Tuesday, February 28, 2023
Medway Planning and Economic Development Board Meeting Minutes

Public Hearing Continuation Medway Commons – Minor Site Plan for Chipotle & Starbucks

**Re: Minor Site Plan Review
Medway Commons - Chipotle & Starbucks
67C Main Street
Medway, Massachusetts**

Re: **Response to Review Comments**
Minor Site Plan Review - Medway Commons – Chipotle & Starbucks
67C Main Street, Medway, Massachusetts 02053

MINOR SITE PLAN FOR
Chipotle & Starbucks
Medway Commons
67C Main Street
Medway,
Massachusetts

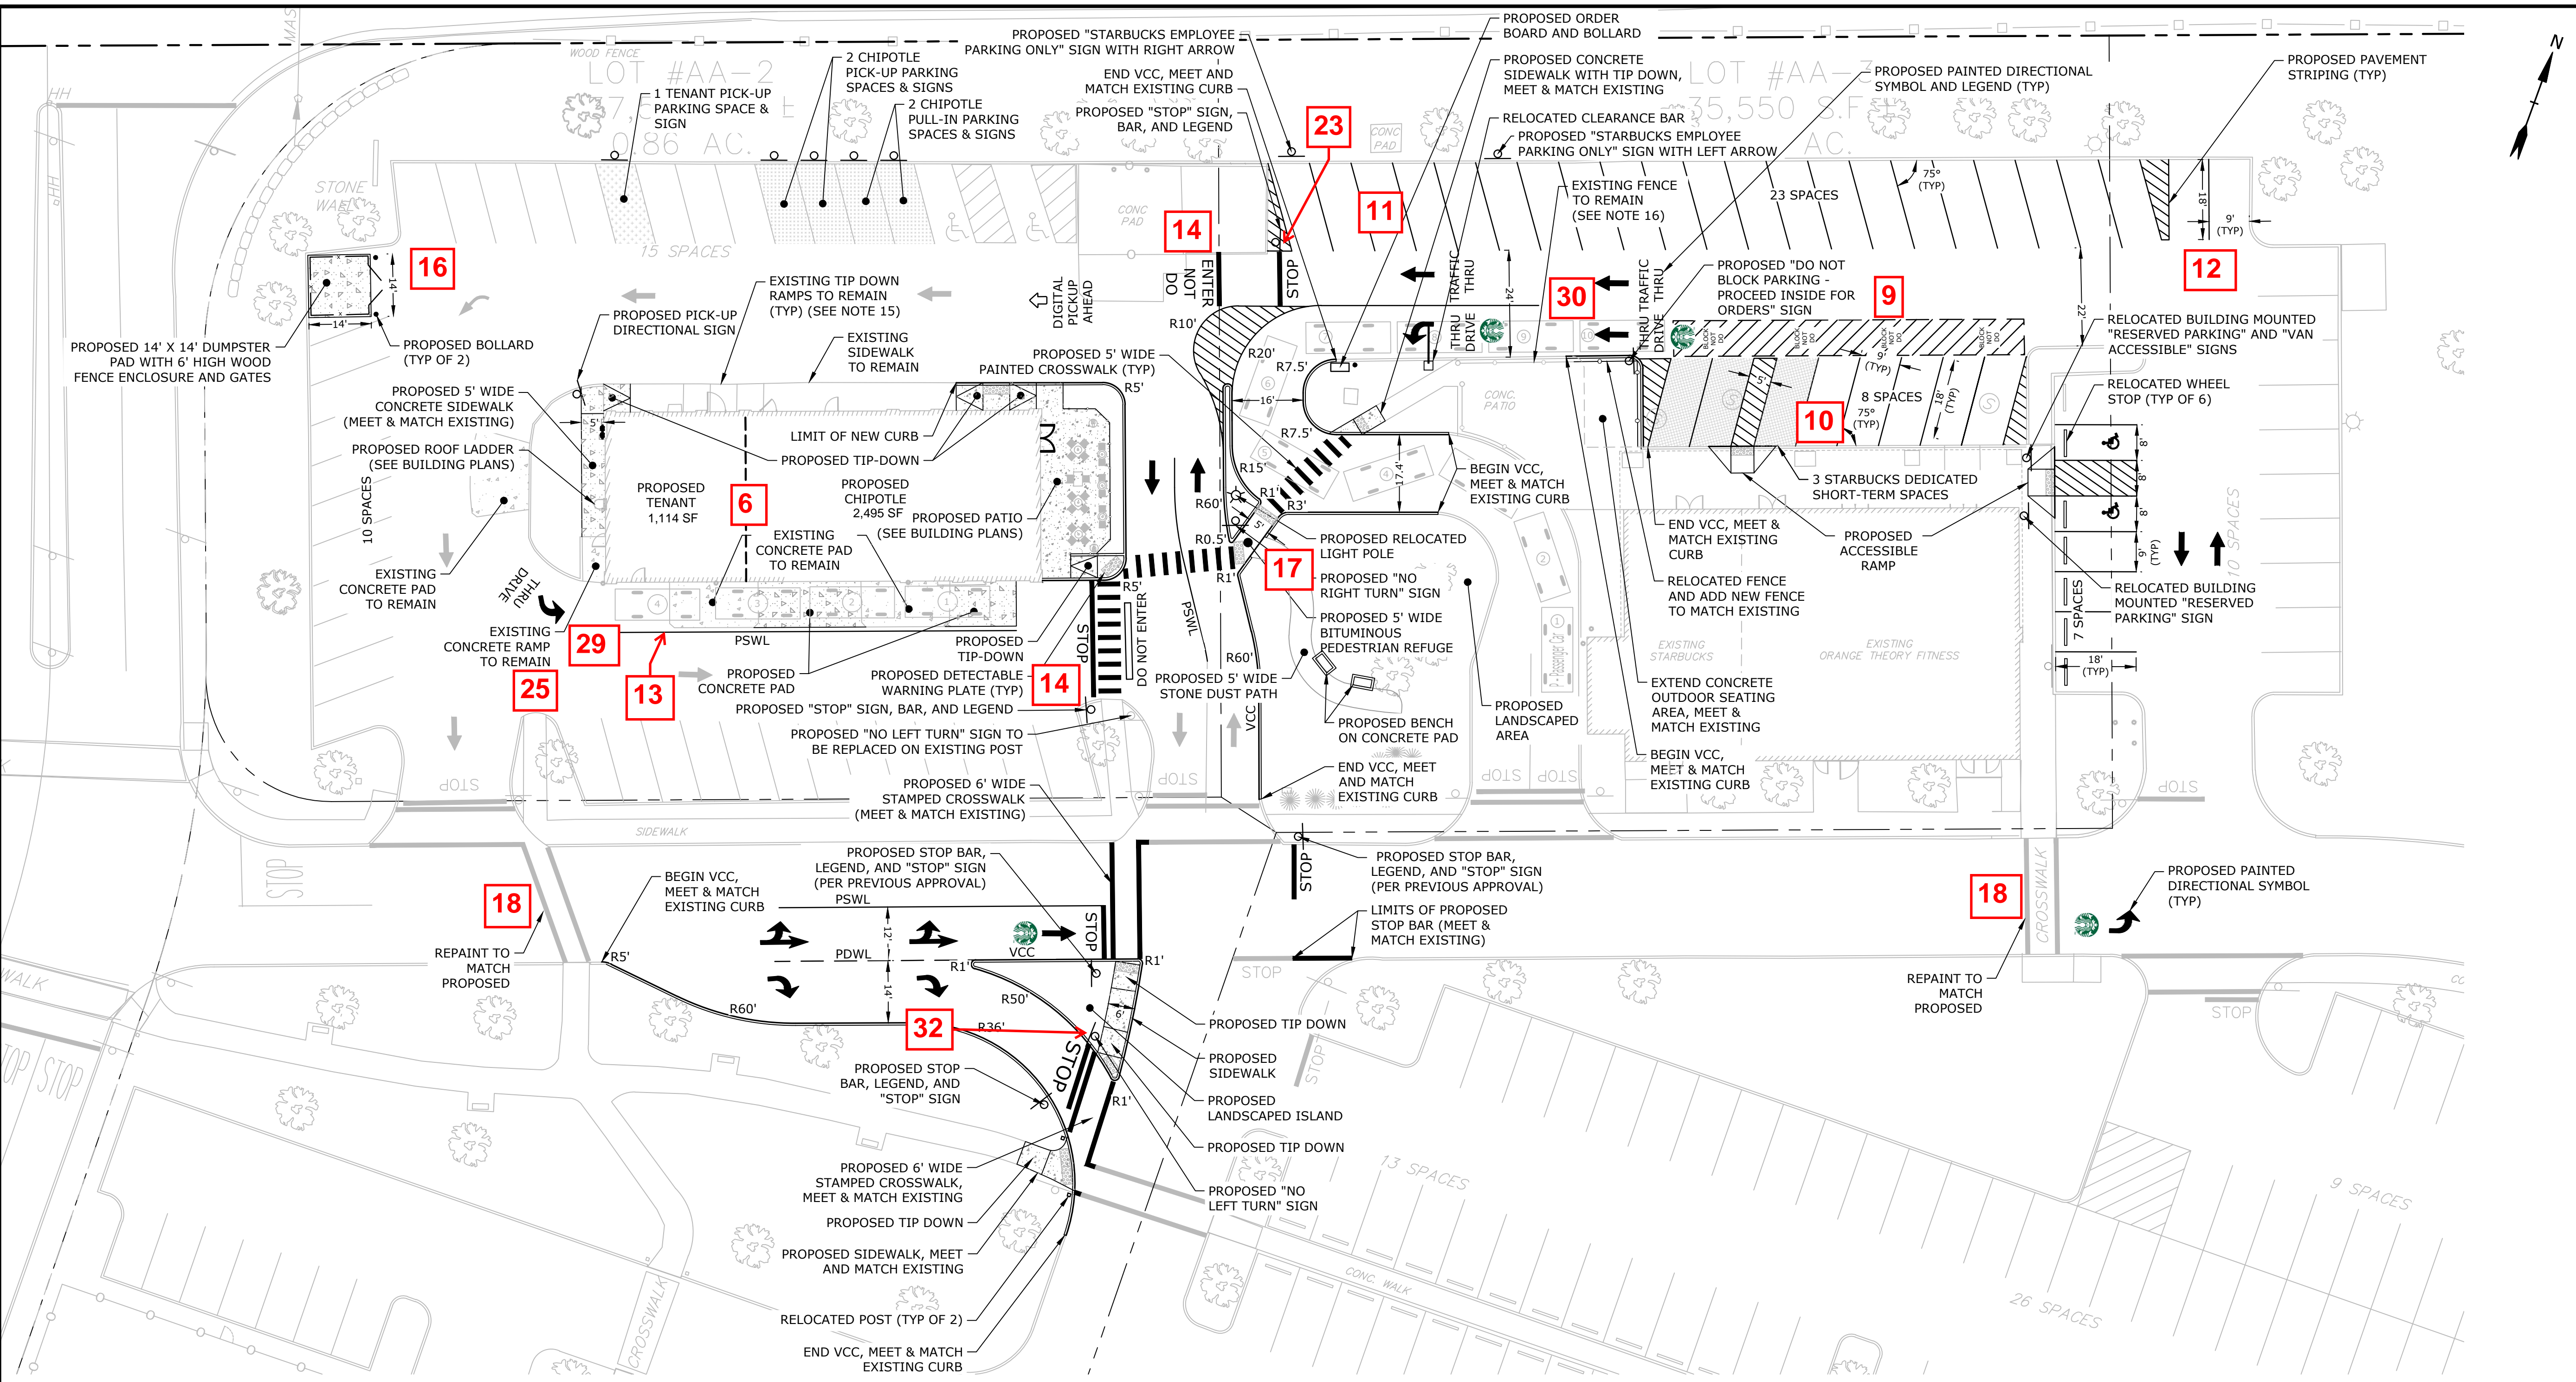
1. Operating Hours 10am-10pm - Consistent with other uses
2. Vertical Datum NAVD88 - Waiver for NGVD29 (2004, 2022)
3. Add waiver requests to Cover Sheet - Added
4. Add Parcel IDs and zoning district to Cover Sheet - Added
5. Existing conditions information - Comment noted
6. Add SF of each tenant to Site Plan - Added
7. Add horizontal site distances - No proposed revisions
8. EV charging stations - No new parking spaces
9. Add "Do Not Block" area - Added
10. Wheel stops may extend vehicles - Removed
11. NE parking conflict w/ drive-thru - Added 6 EE signs

12. East parking conflict by dumpster - Adjusted
13. Chipotle lane striping - Added at drive-thru
14. Add Stop & Do Not Enter signage - Added
15. Show pavement limits, how remove markings - Shown & black out paint
16. Add dumpster enclosure detail - Added
17. Add detectable warning plates - Added
18. Repaint existing stamped crosswalks - Added
19. No stormwater related issues - Noted
20. Add trash and fire truck circulations - Added
21. Delivery operations - AM prior to opening

22. MUTCD signage - Added "regulatory" to note
23. Add stop sign to north side of Starbucks - Added
24. Enforce 1-way circulation - Added signage and markings
25. Review sidewalk - Area not being revised
26. Info on second tenant to Town - Will provide
27. Provide backup calcs for trip generation - Provided
28. Provide observed queuing count data - Provided
29. Add Chipotle queue - 4 cars added
30. Add Starbucks queue - 10 cars added
31. Estimate peak parking demands - Meeting zoning reqs
32. Unwanted turns at intersection - Added "No Left Turn" sign

SITE PLAN

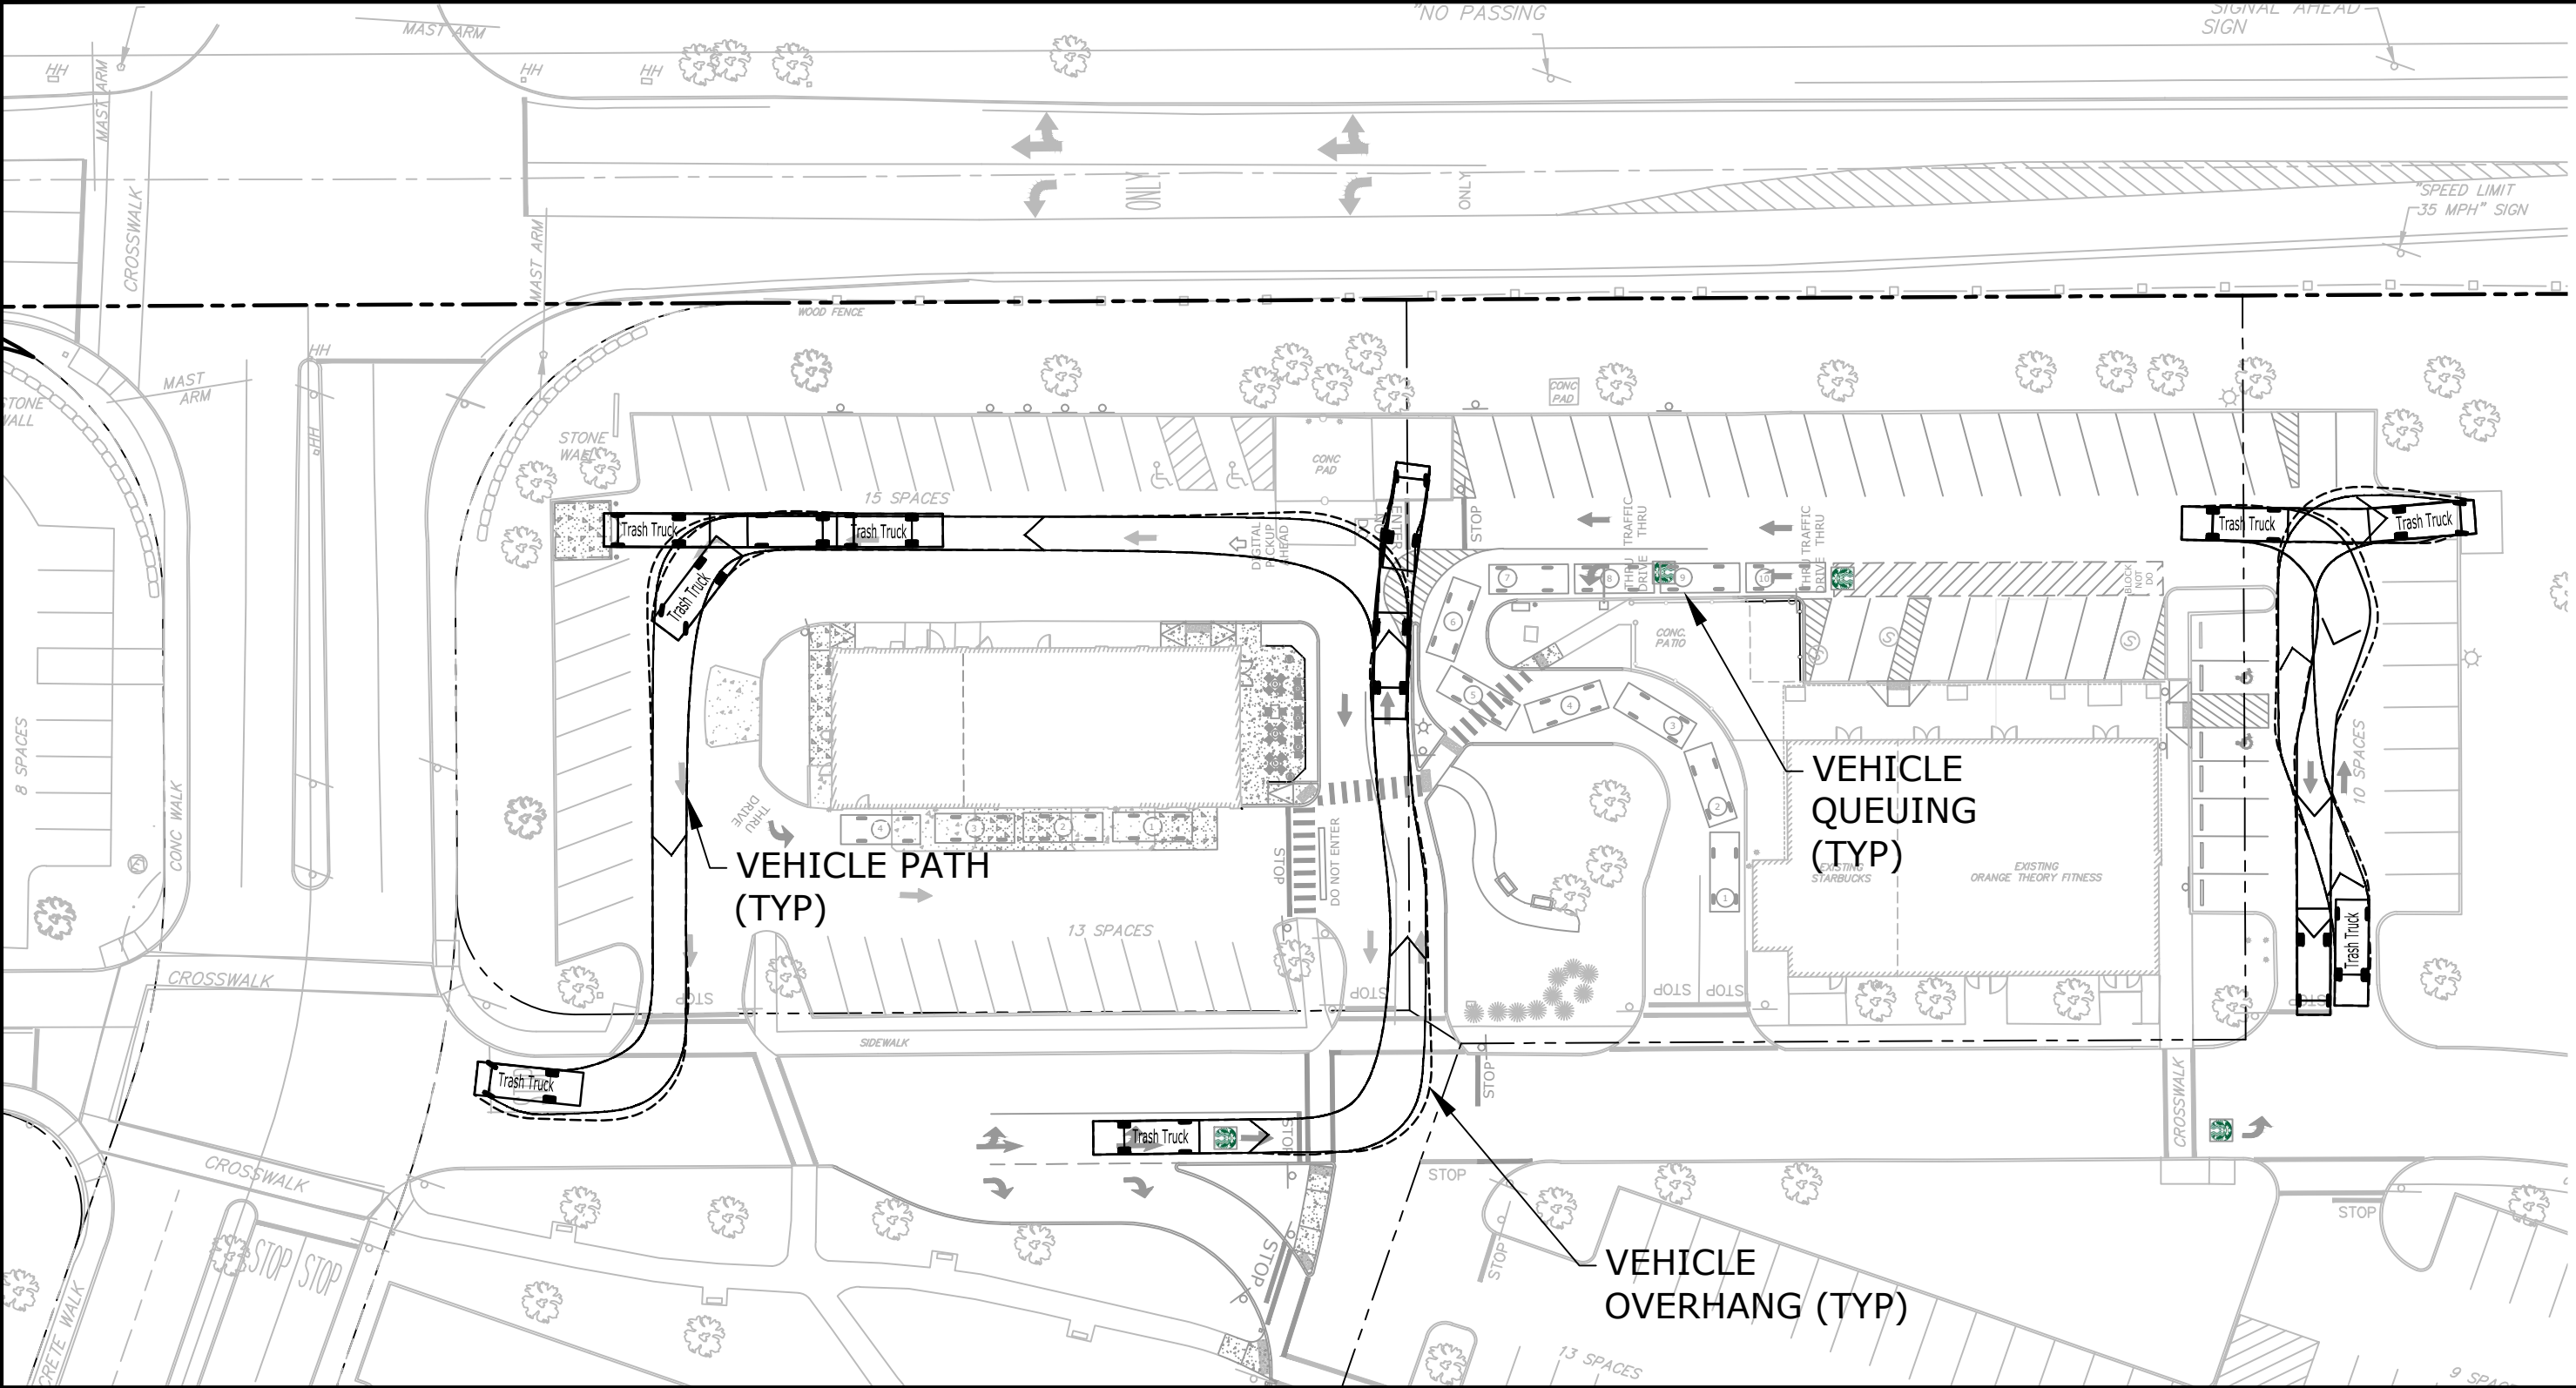
The peak queue based on similar Chipotle restaurants is 4 cars and an illustration has been added to the Site Plan Sheet C-102.

The peak typical queue based on the current Starbucks configuration is 10 cars which has been added to the Site Plan Sheet C-102.

A “No Left Turn” sign has been added to the Site Plan Sheet C-102 to further control traffic at the revised intersection.
